TO: Newton Board of Aldermen
FROM: Srdjan Nedeljkovic – Newton Highlands Neighborhood Area Council
DATE: August 31, 2014
SUBJ: NHNAC Working Group Response regarding NHNAC's Plan B for Zervas

The Newton Highlands Neighborhood Area Council recently presented its Plan B alternative site plan for the Zervas renovation/expansion. Some members of the Zervas School Building Committee (ZSBC) / Design Review Committee (DRC) have expressed concerns about Plan B. In this memo, the NHNAC responds to those concerns, with comparisons to the ZSBC's Plan A. The site plans for both are shown on the last page.

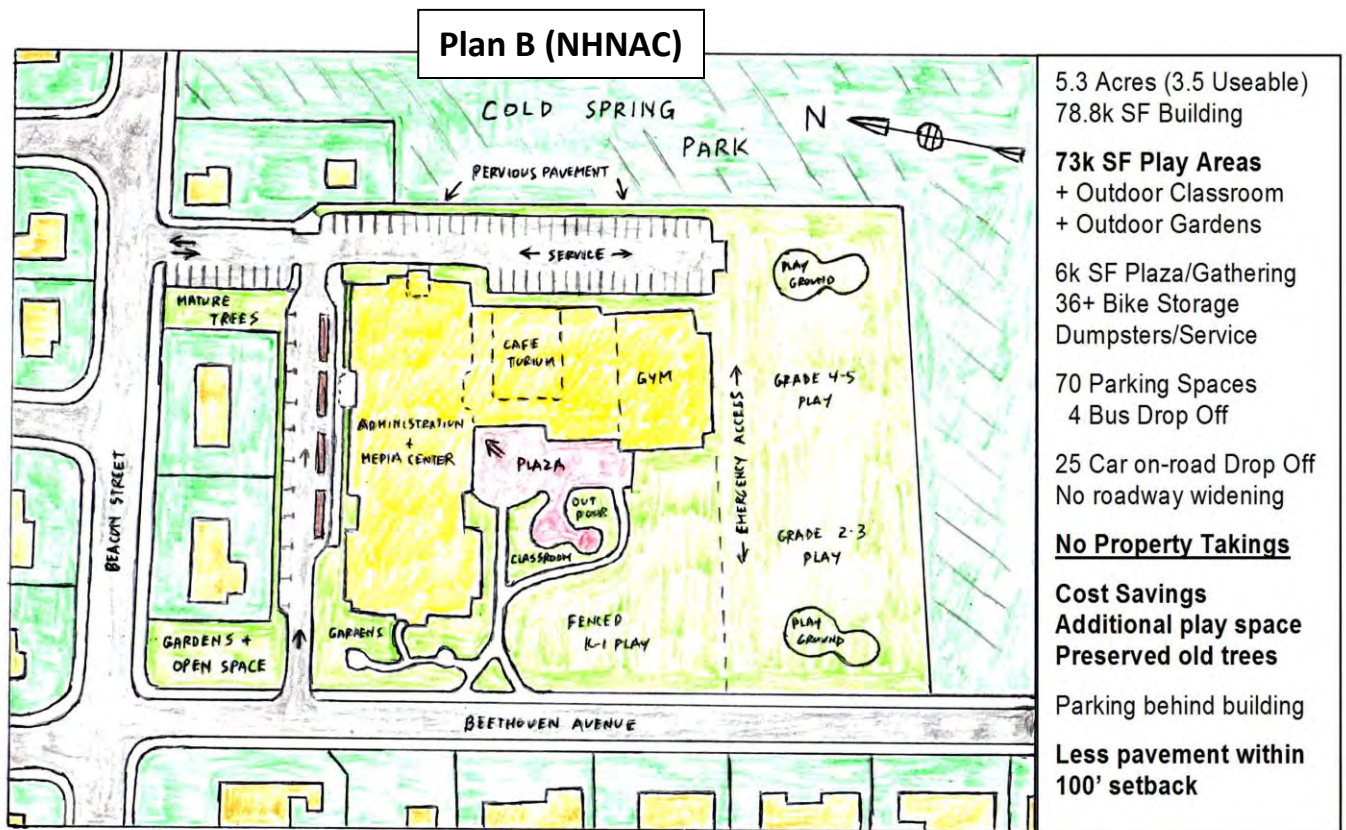
9. *Concern: Plan B extends parking within a required 25-foot wetlands buffer.*

The ZSBC’s Plan A itself includes parking and a large building structure within the 100-foot buffer zone and parking within the 50-foot zone. **Plan B actually has a smaller building footprint within the 100-foot buffer zone and less parking within the 50-foot zone.**

[State law](#) allows for up to 5,000 sq. ft. of potential development within wetlands. Plan B includes about 5,000 sq. ft. of pervious pavement for parking within the 25-foot buffer zone, and (of course) none within the actual wetland.

Which is more environmentally obtrusive?

- Plan A: A larger building footprint within the 100-foot setback and the destruction of dozens of mature trees
- Plan B: Some parking on pervious pavement adjacent to the wetlands, with controlled run-off
